October 20, 2023

Subject: Engineering Peer Review
 Ocean Pines Condominium Development
 Bourne, MA
 CEC Project 335-785

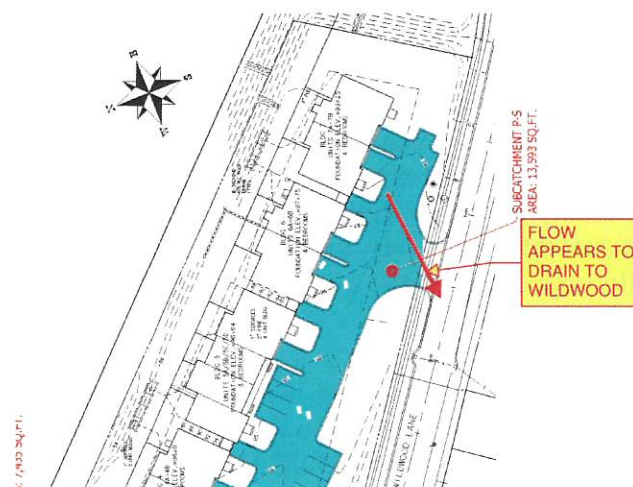
Comment 11: The runoff from the pavement drains directly to Wildwood Lane as opposed to being channelized in the centerline of the access drive and collected in catch basins as depicted on the drainage exhibits. See below for an excerpt of the drainage exhibit for reference. This will alter the drainage performance as the runoff will bypass the controls proposed as part of this phase of development and increase flows to the stormwater basin behind Unit 12 Ocean Pines and should be reviewed.

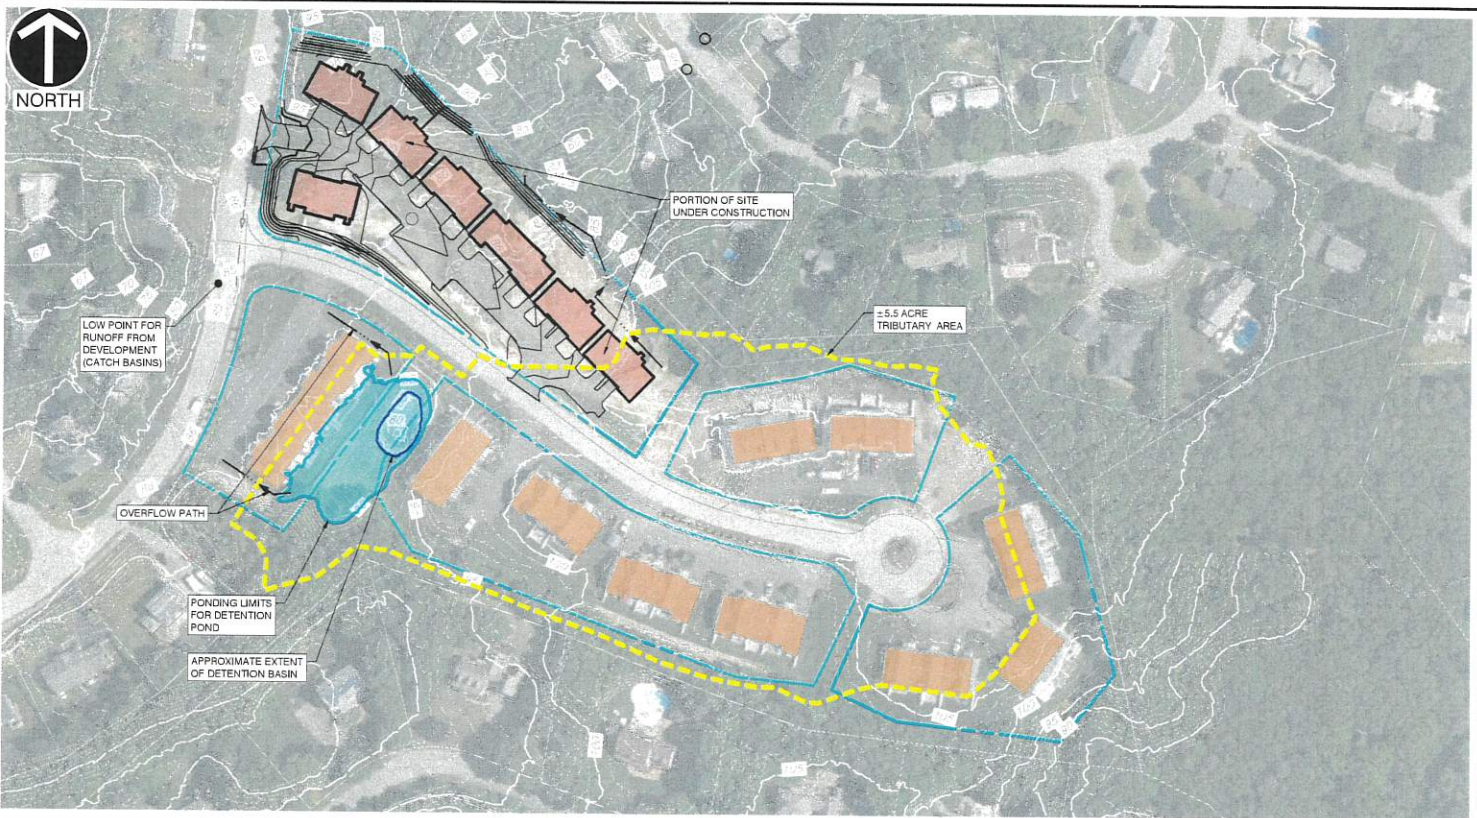
Comment 7: The tributary area that was modeled to the stormwater pond includes approximately 1.7 acres of area; however the total tributary area is likely closer to 5.5 acres or more when including the building and parking areas. See figure SP04 for a graphical depiction of the tributary drainage area and ponding limits of the existing detention pond. Although some of the areas included in the 5.5-acre overall tributary area have been modeled to drain to the Cultec systems, the runoff exceeding the 10-year storm events that these systems we designed for would ultimately overflow these systems and drain to the existing stormwater basin resulting in more flows in the basin than modeled. Based on available GIS information, it appears that the basin, as it currently exists, is approximately eight (8)-ft deep with an approximate footprint of 1,900 sf within the stone walls that define the basin. Up to the defined limit of the

basin, there is approximately 7,000 cf of stormwater storage volume. Above the defined limits of the basin, there is approximately three (3) additional feet of storage capacity up to the elevation of the rear of the Unit 12 Ocean Pines building before stormwater would be to overflow on the surface adjacent to the Unit 12 building toward Ocean Pines Drive. Up to this overflow elevation there appears to be a total of approximately 32,200 cf of stormwater storage volume capacity. This maximum storage volume is approximately 50% of the total available storage volume modeled in the 2007 Drainage Analysis.

The pond is located in a low point behind the Unit 12 building and does not appear to have an emergency overflow that would allow for stormwater to drain without impacting the Unit 12 building. It was observed by the Association during recent storm events that this pond was full up to fence line of the 12 Ocean Pines homes and in danger of overtopping. See below for photographs of the basin if this condition.

It is recommended that the Developer review the tributary area draining to the basin and overall sizing of the detention basin to confirm that the basin has sufficient capacity to control runoff from storm events up to and including the 100-year storm event. Additionally the basin design should incorporate an overflow that provide a means for stormwater to safely drain from the basin should the site experience stormwater flows in excess of the design capacity.
